# CITY OF ALBUQUERQUE

PLANNING DEPARTMENT – Development Review Services

December 18, 2015

**RE: North I-25 Corporate Center (File: B18D001)  
Amended Drainage Master Plan  
Engineer's Stamp Date: 11-4-2015**

**EXISTING BASIN MAP**

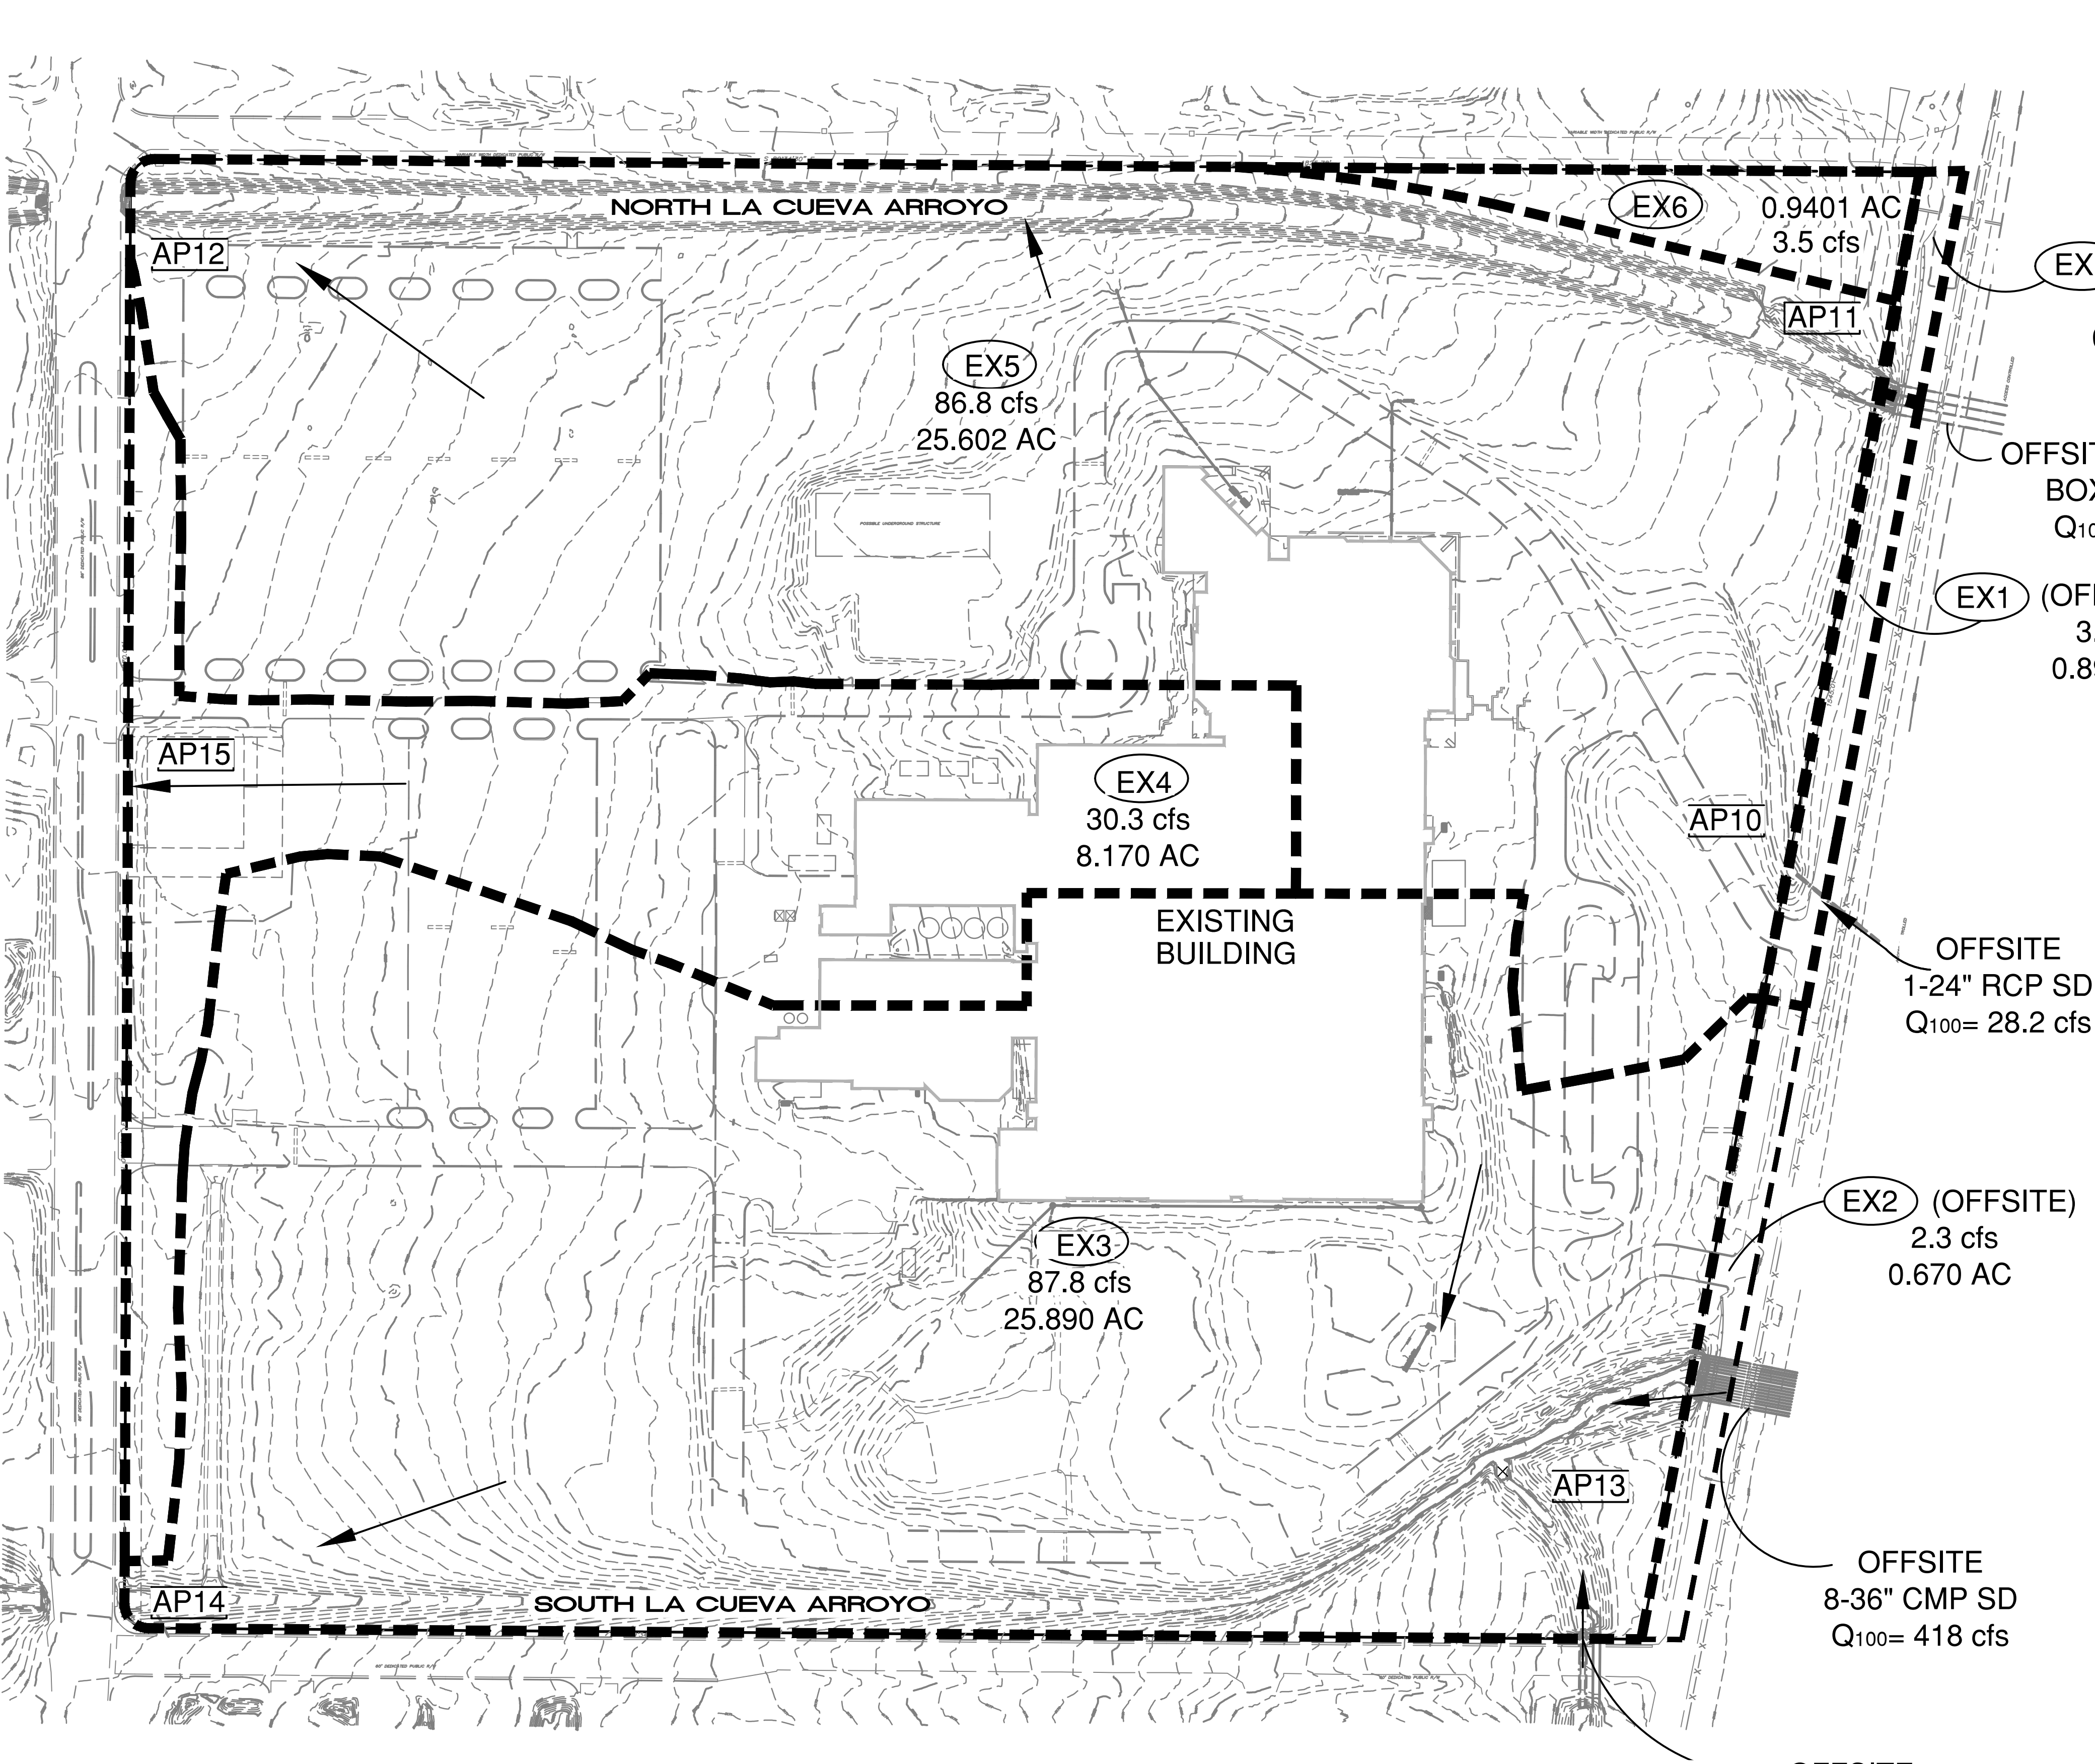
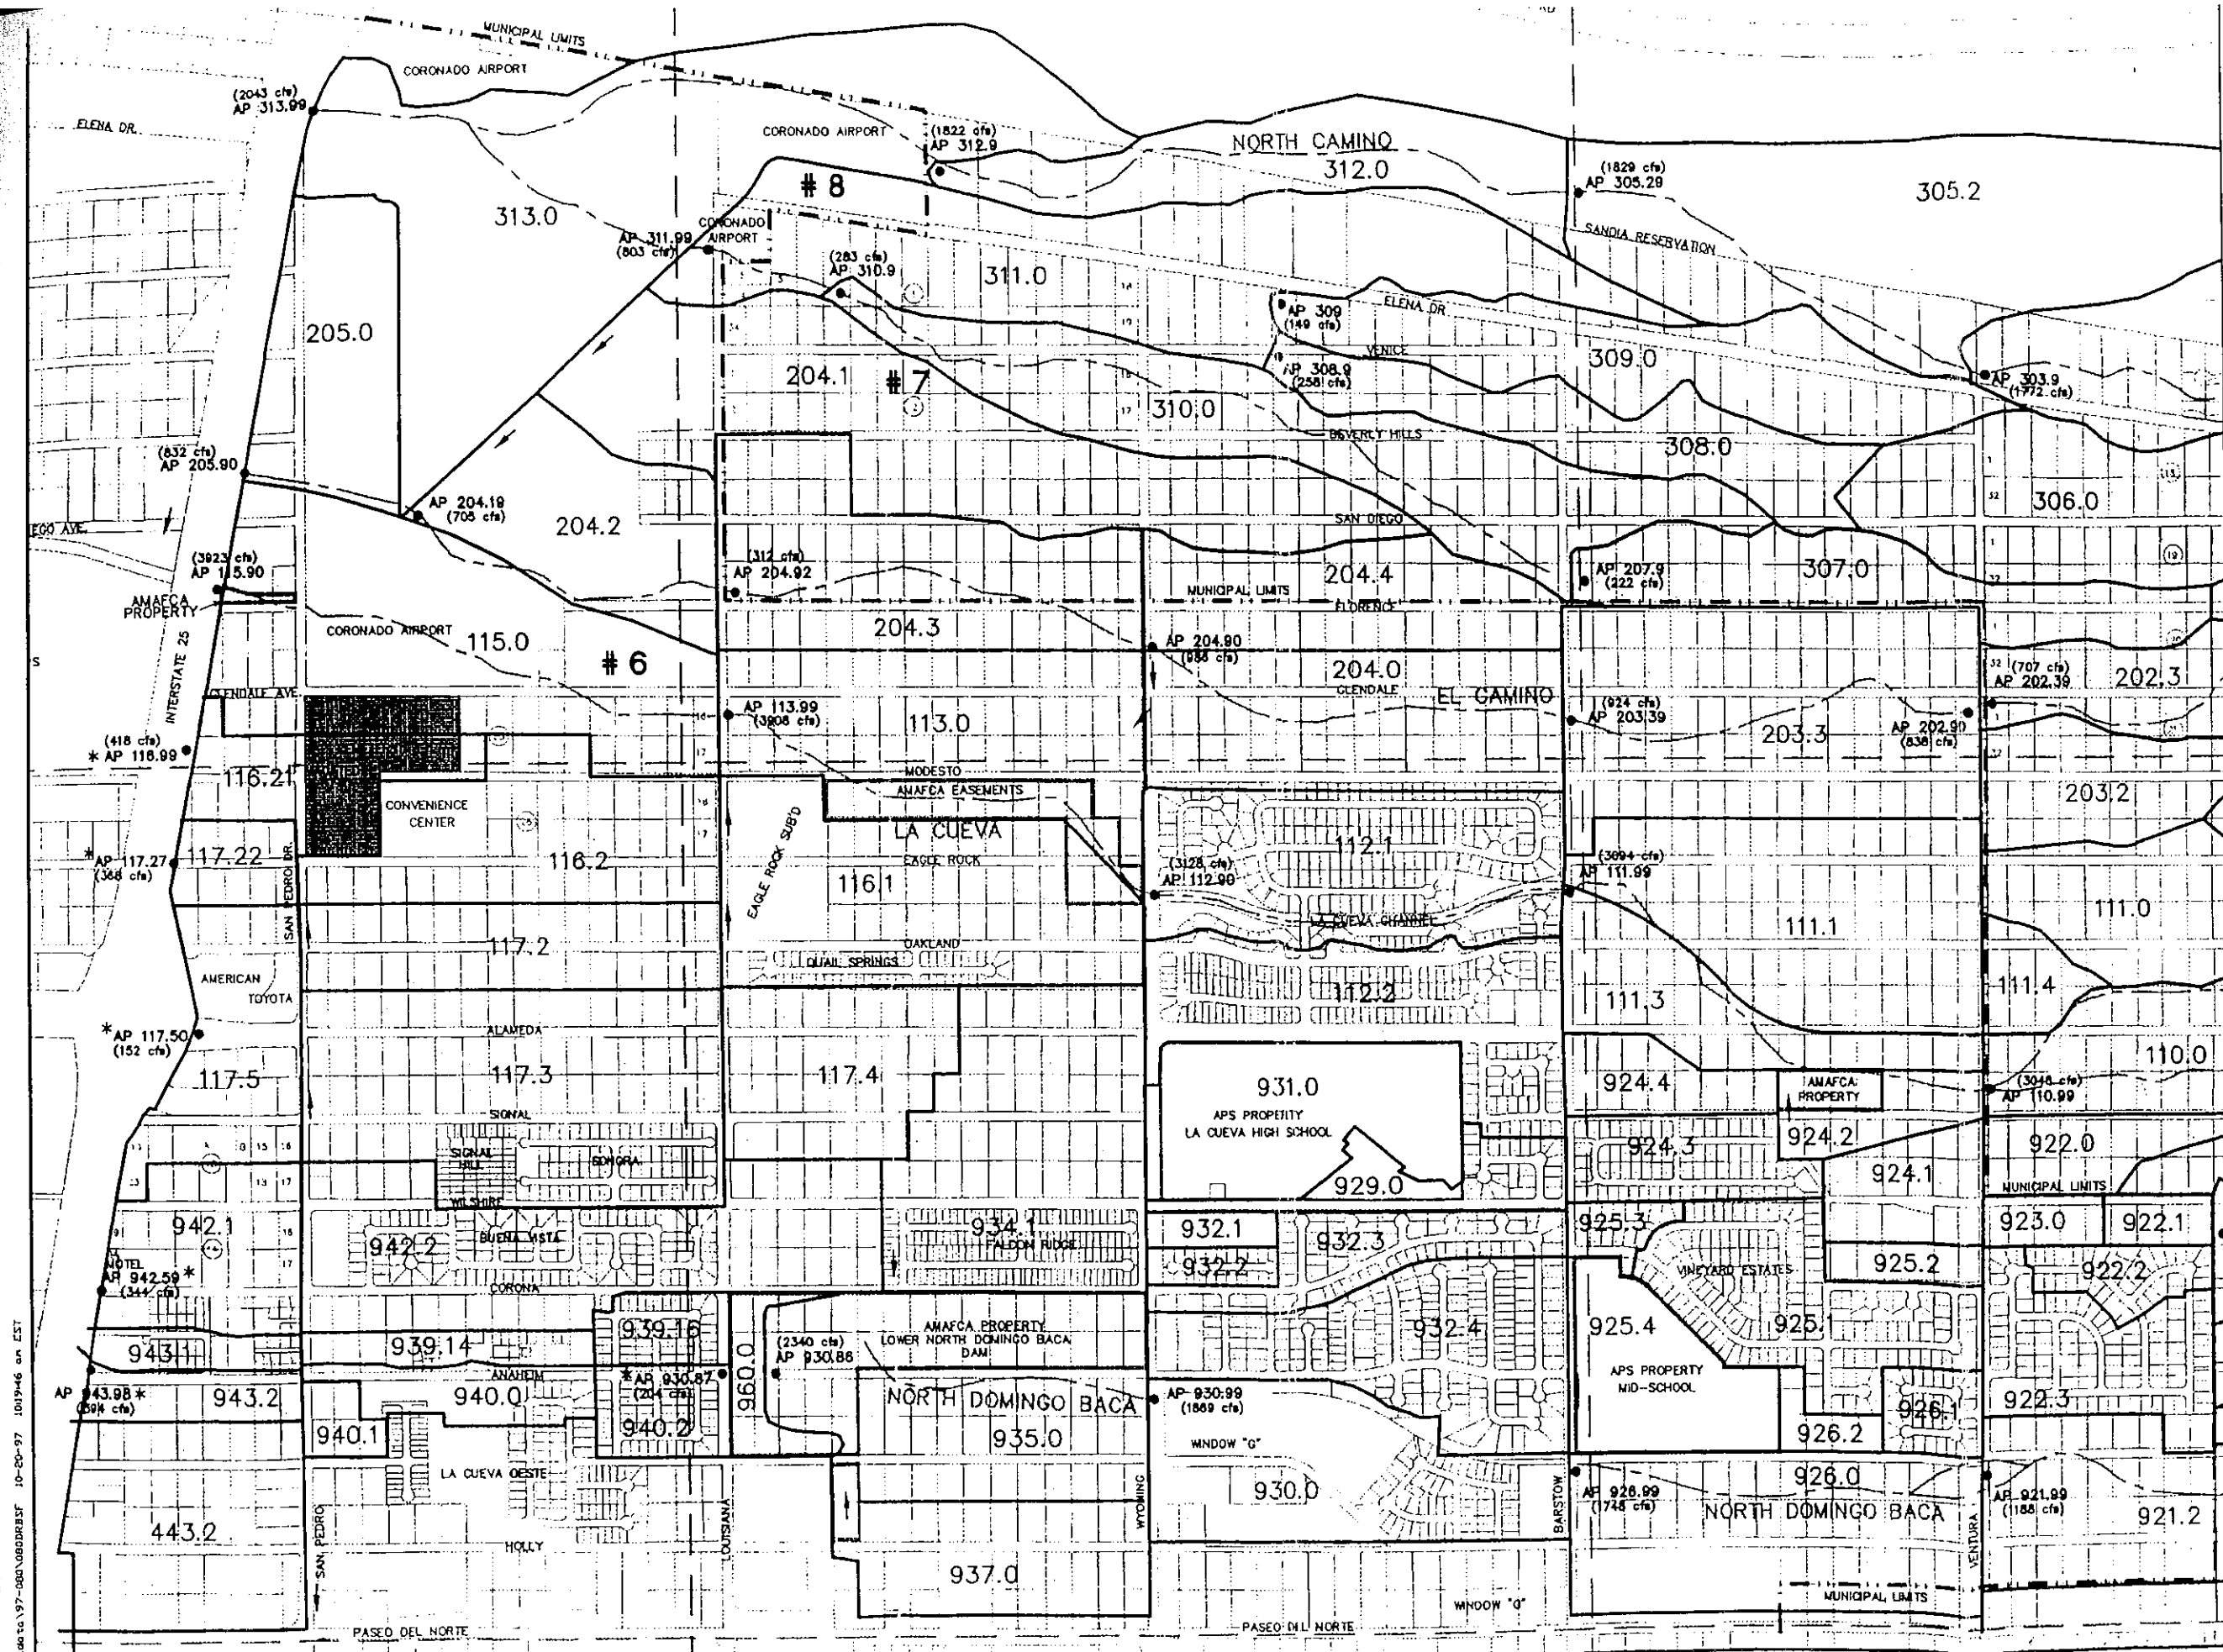
13. Existing Condition peak flows shown on excel sheet do not match those shown on the basin map.
14. Junctions:
  - a. Show analysis of manifold and junction box, and provide preliminary details

# Culvert Report

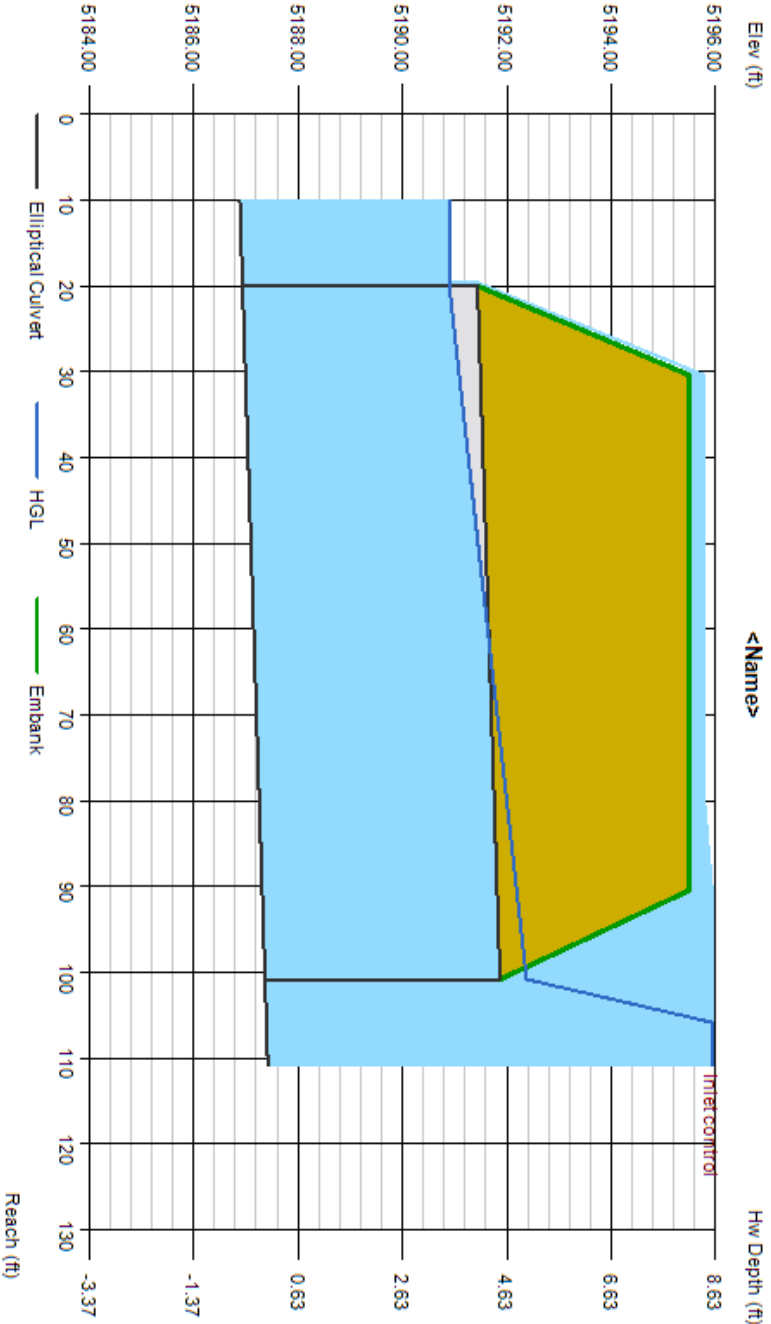
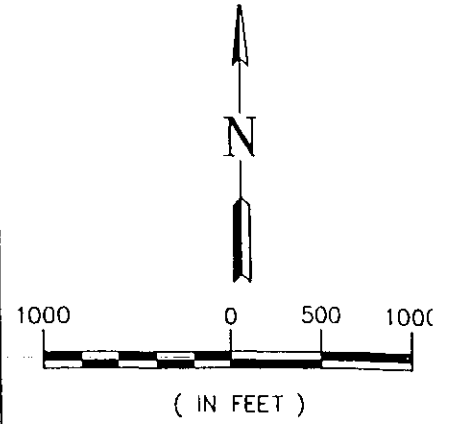
11. Page 5 (1st paragraph): How did the San Pedro Storm Drain Report account for the existing culvert being under capacity? It only carries 248 cfs, and the flow is 368 cfs. Is DMD aware of the deficiency? Are there already plans to improve this condition? To what degree have you coordinated with DMD?
